## **Frodsham Solar**

### **Response to Local Planning Authority and Statutory Environmental Body Relevant Representations**

PINS Ref: EN010153

Document Ref: EN010153/DR/8.5

**Figure 1**

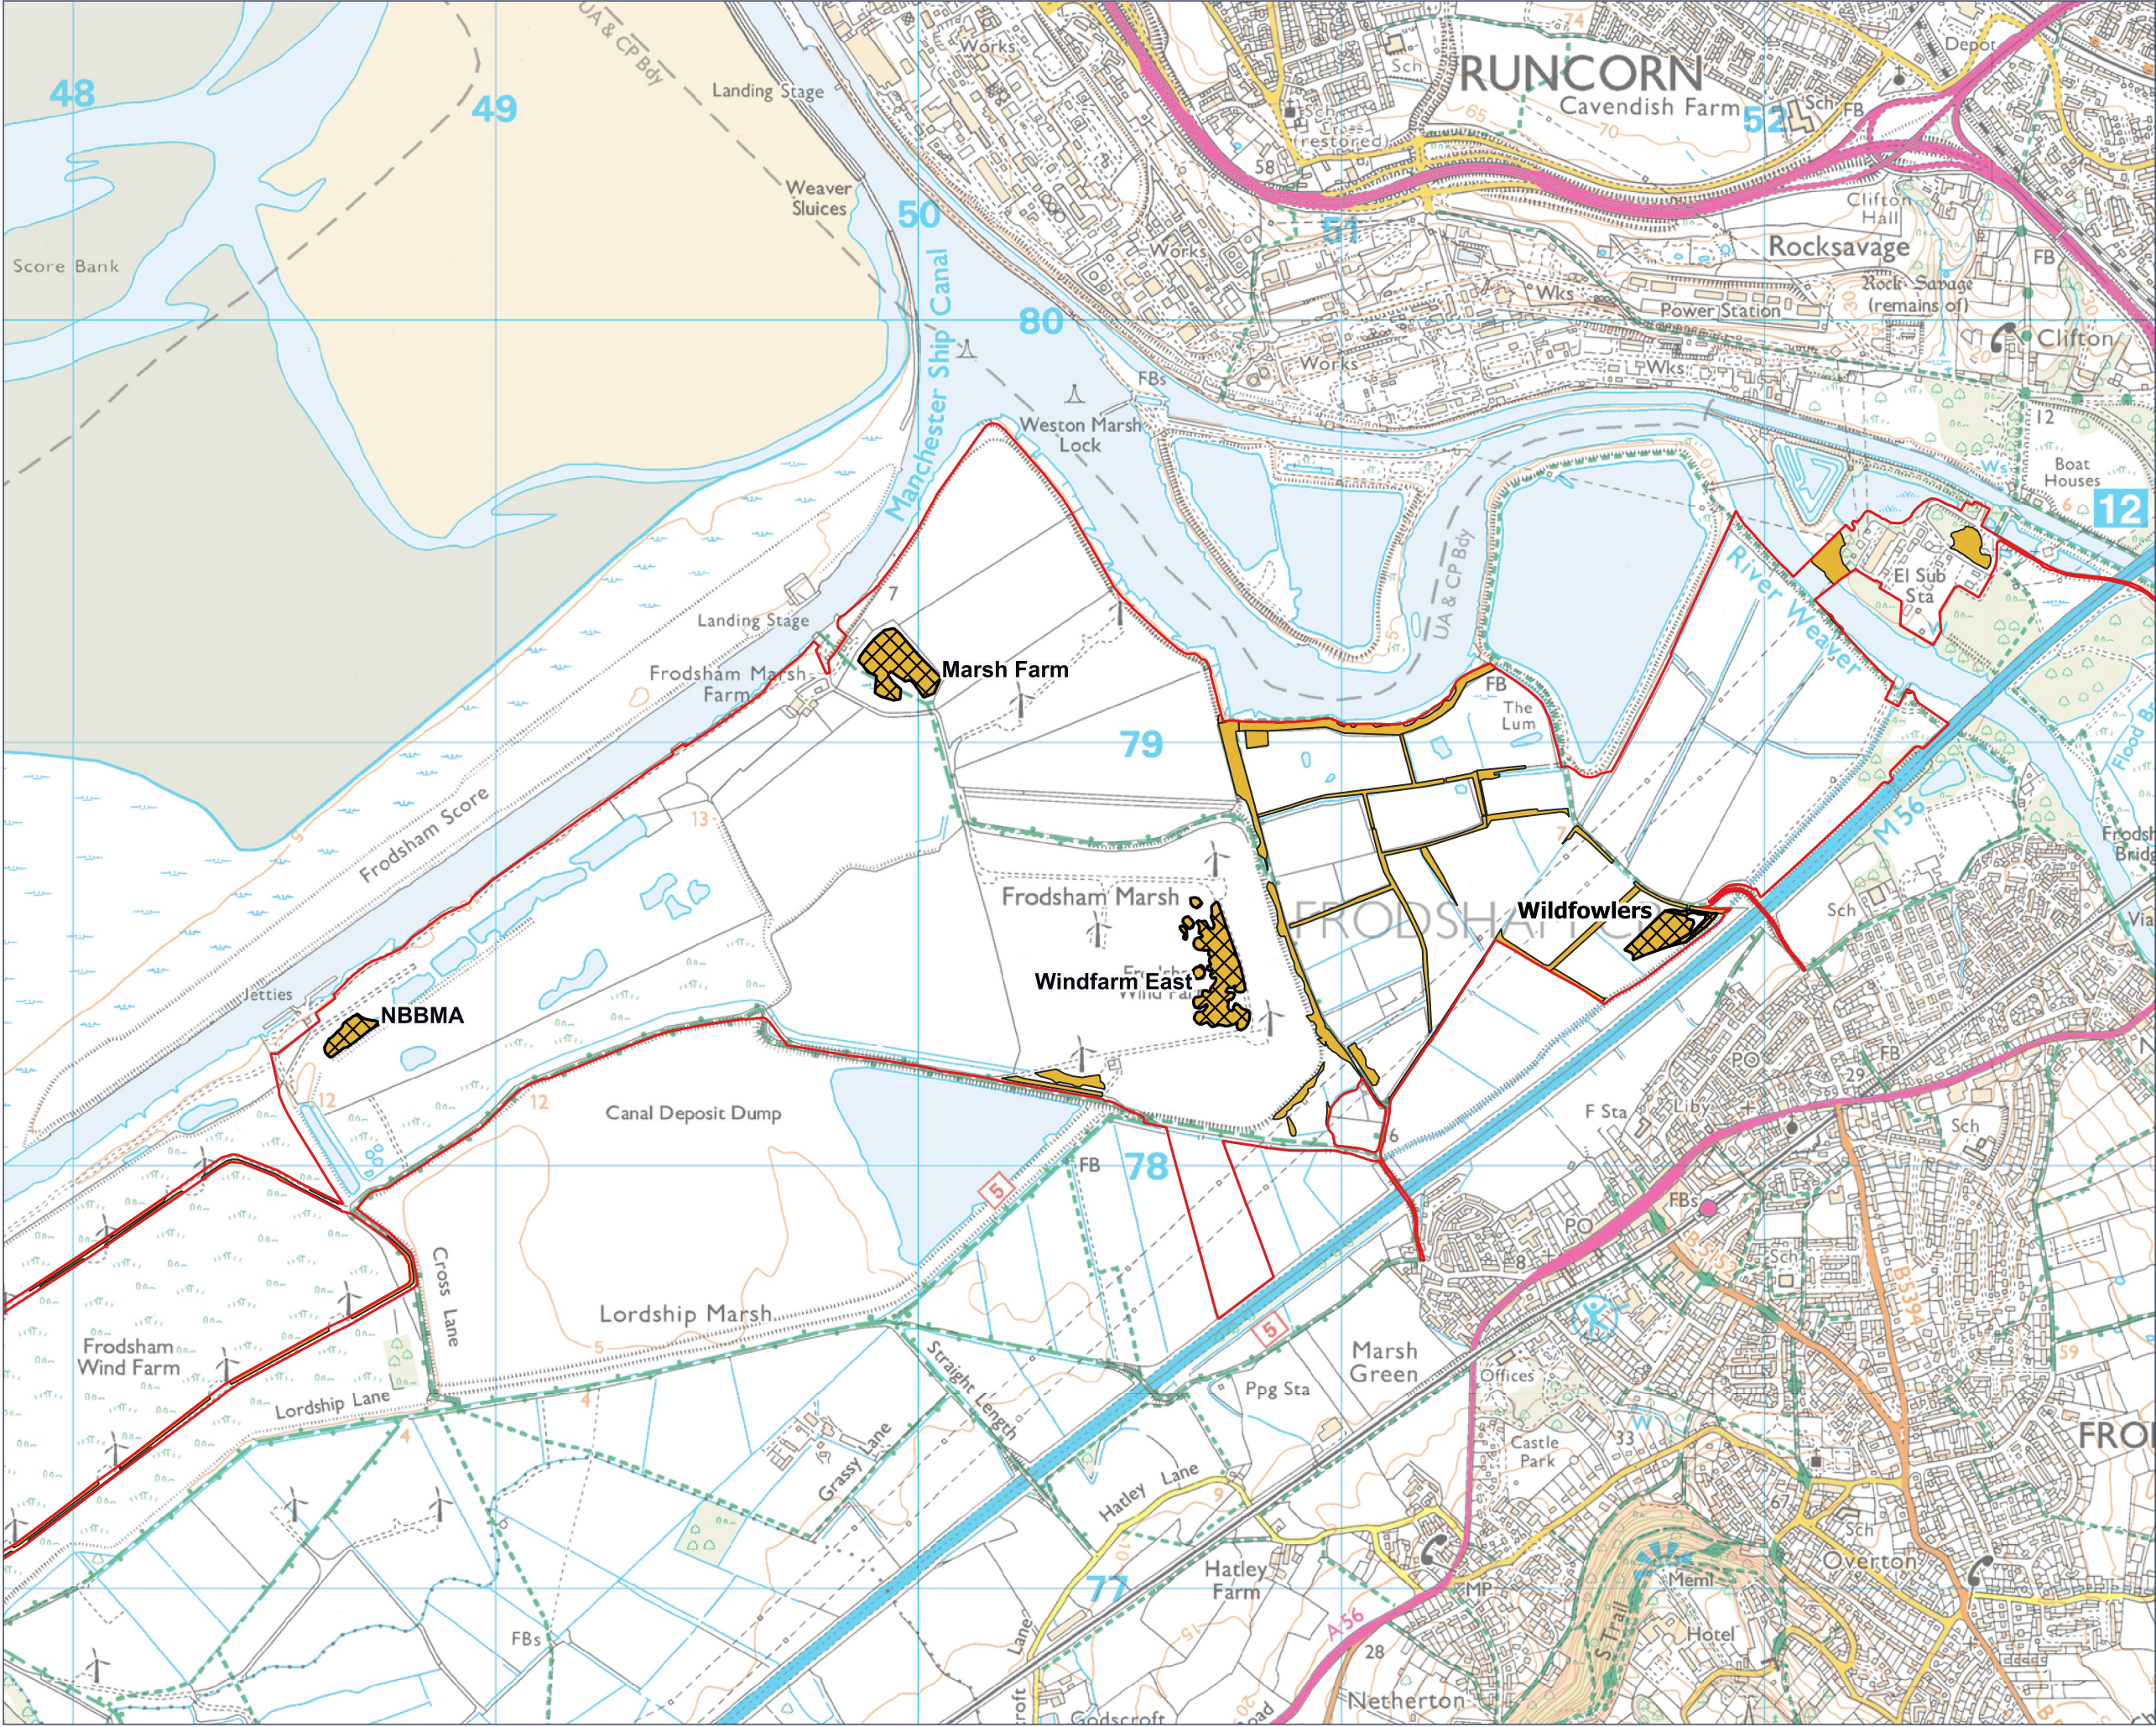
Ref	Paragraph Number	Comment	Applicant's Response
CWACC7.61	7.68	Further east, the other area of FLL is shown as an area of moderate potential and referred to as the "Redwall Reedbed" in the Information to Inform Habitats Regulations Assessment report (EN010153/DR/5.3) ( <b>APP-125</b> ), which is field parcel 11 in Figure 4 "the Proposed Development Areas - With Cells" of the same document and an area of priority habitat reedbed in Natural England's Magic mapping tool. There is habitat loss proposed in this area. Although there were low numbers of birds recorded here and there is a buffer from the River in this field parcel, the expansion of the area of land retained would help to provide further habitat for birds if managed and also assists with issues with reedbed habitat loss in BNG calculations.	Additional analysis of the ornithology field survey data has been undertaken, supplemented with more recent WeBS data, in response to queries raised by Natural England. The additional analysis is presented in the revised <b>Information to Inform Habitats Regulations Assessment (as updated alongside this submission)</b> and provides further evidence of the variable distribution and use of the birds across the Site. It is the Applicant's position that full mitigation is provided for all SPA and other bird use across the Order Limits, through both the creation of the NBBMA and habitat measures detailed in the <b>Biodiversity Net Gain Report (APP-143)</b> . Further Information On The Classification Of Reedbeds is provided as Appendix C.

Following receipt of Relevant Representations by CWACC a review has been undertaken of particular reedbed habitats against both JNCC and UKHab definitions. Following the review, an area formerly classified as reeded located within Frodsham Windfarm East has now been reclassified as g3.16 instead due to not meeting soil moisture criteria. Further, several areas which may meet the UKHab definition of reedbed, are not considered priority habitat but rather smaller stands of reed.

Areas of reed associated with ditches were not specifically assessed, however due to the functioning of these ditches in holding water it is assumed that the water table would be at surface level for most of the year.
